Sequoyah Nuclear Plant, Unit 1 and Unit 2
Facility Operating License No. DPR-77 and DPR-79
NRC Docket No. 50-327 and 50-328

Subject: Completion of Required Action by NRC Order EA-12-051, Reliable Spent Fuel Pool Instrumentation

**RESPONSE TO THE NRC REQUEST FOR ADDITIONAL INFORMATION REGARDING
OVERALL INTEGRATED PLAN FOR RELIABLE SPENT FUEL POOL INSTRUMENTATION**

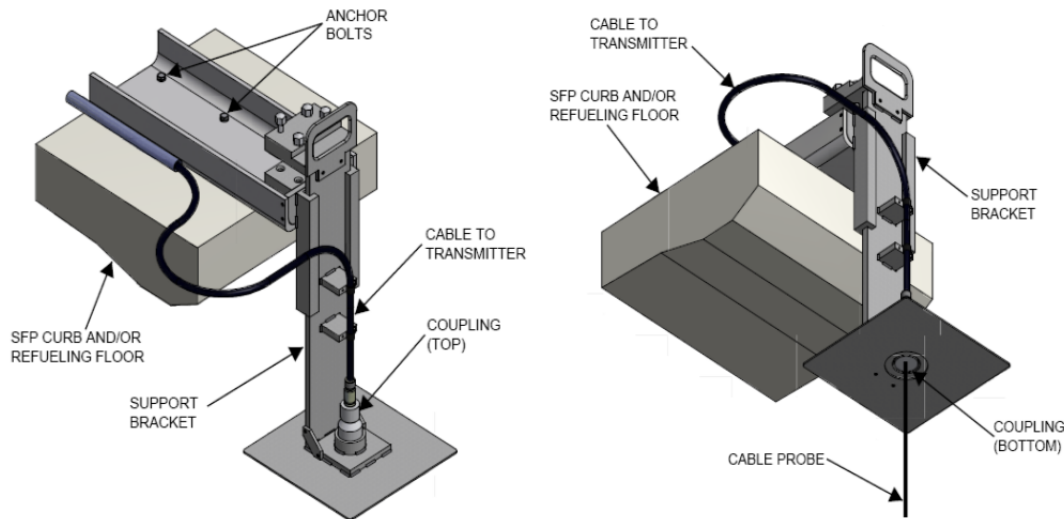
- a) The design criteria used to estimate the total loading on the mounting device(s), including static weight loads and dynamic loads. Describe the methodology that will be used to estimate the total loading, inclusive of design basis maximum seismic loads and the hydrodynamic loads that could result from pool sloshing or other effects that could accompany such seismic forces.*
- b) A description of the manner in which the level sensor will be attached to the refueling floor and/or other support structures for each planned point of attachment of the probe assembly. Indicate in a schematic the portions of the level sensor that will serve as points of attachment for mechanical/mounting or electrical connections.*
- c) A description of the manner by which the mechanical connections will attach the level instrument to permanent SFP structures to support the level sensor assembly.*

- b) The level sensor cable assembly is suspended from a support bracket, which is secured to the refueling floor and/or spent fuel pool curb using concrete anchor bolts. The level sensor cable suspended in the SFP is attached to a threaded coupling, which is secured to a support bracket. The cable leading to the transmitter is also attached to the threaded coupling. **See Attachment 1, Item 12.** The generic illustrations below depict these attachments.

SQN Plan View of SFP Area - Response to RAI #1

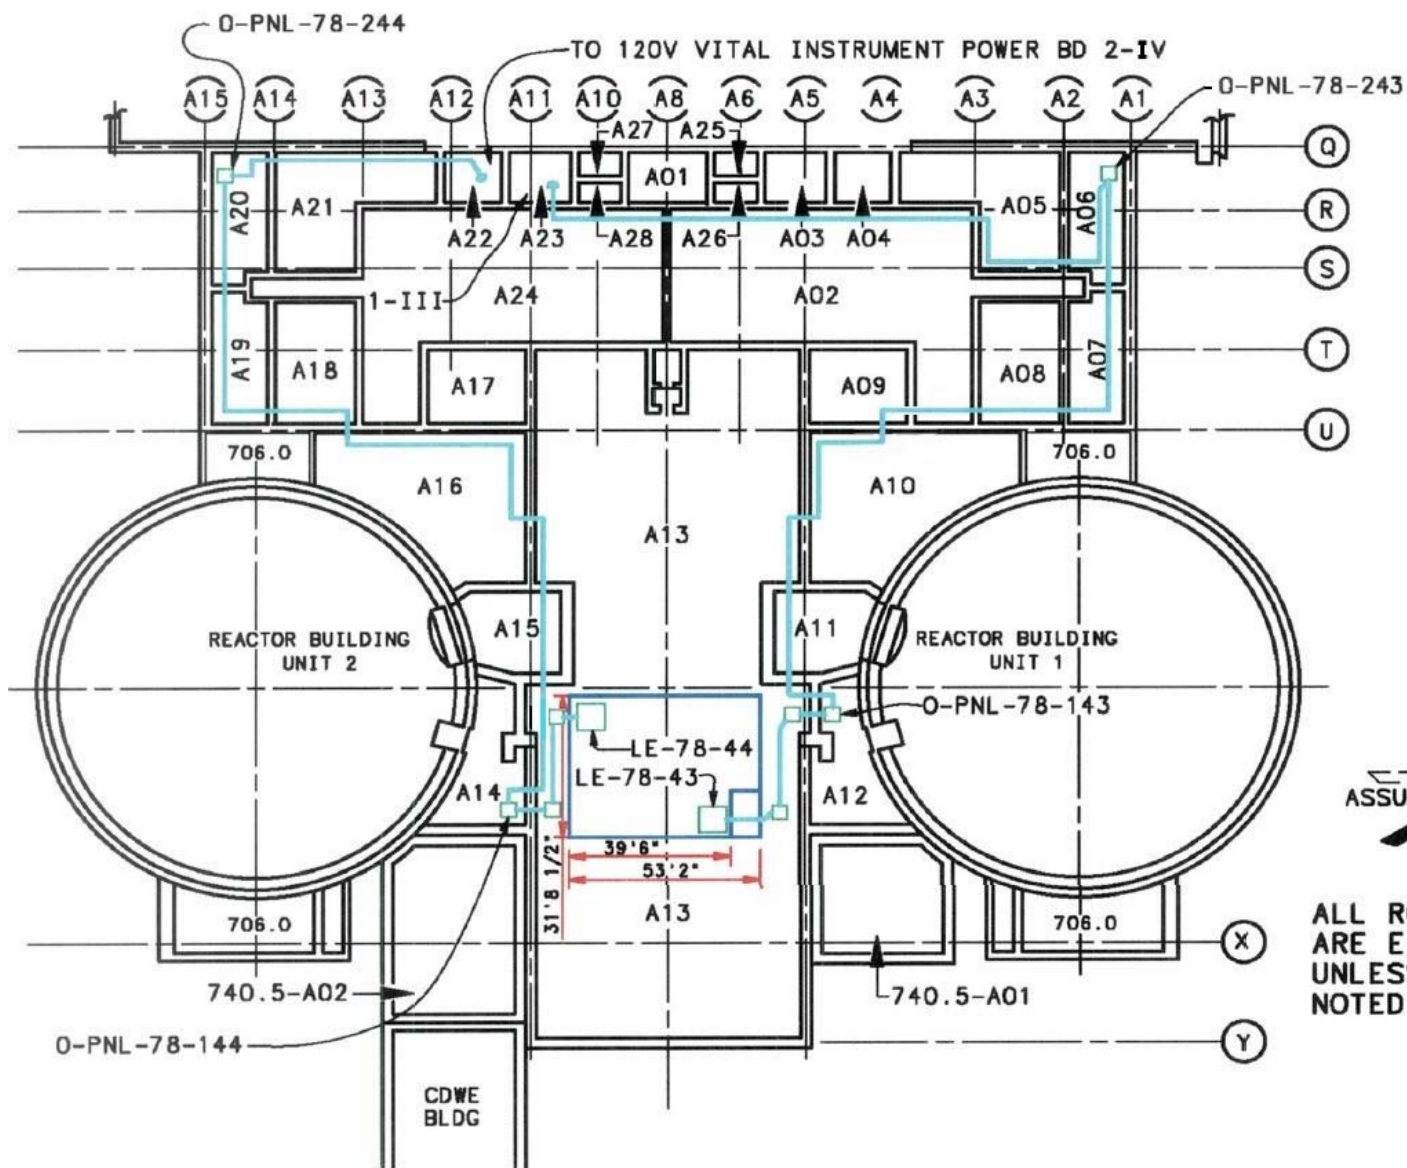
Please provide a clearly labeled sketch or marked-up plant drawing of the plan view of the SFP area, depicting the SFP inside dimensions, the planned locations/placement of the primary and back-up SFP level sensor and mounting brackets, and the proposed routing of the cables that will extend from the sensors toward the location of the read-out/display devices.

See Attachment 2 for plan view of the spent fuel pool (SFP) area, depicting the requested information.

Cable and conduit for each channel maintain trained separation from the power source to their respective instrument enclosures, which are mounted in separated areas of the plant. **See Attachment 2.**
